## SAF Trailer Axles – 5.75" Diameter (X-Series) Disc and Drum Brake and 5" Diameter Drum Brake Configurations

## Product Change Notice Effective with shipments beginning September 12, 2011 TIS (Tire Inflation System) prep holes changed from (3) 1/4"-18 Threaded Holes to (1)1/8"-27 Threaded Hole

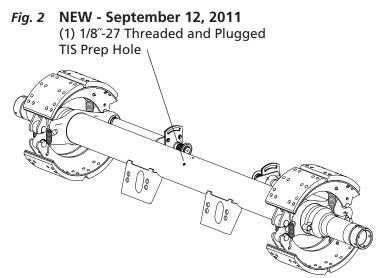
Prep holes in SAF axles will change from (3) 1/4<sup>-7</sup>-18 threaded and plugged holes (*Fig. 1*) to (1) 1/8<sup>-27</sup> threaded and plugged hole (*Fig. 2*).
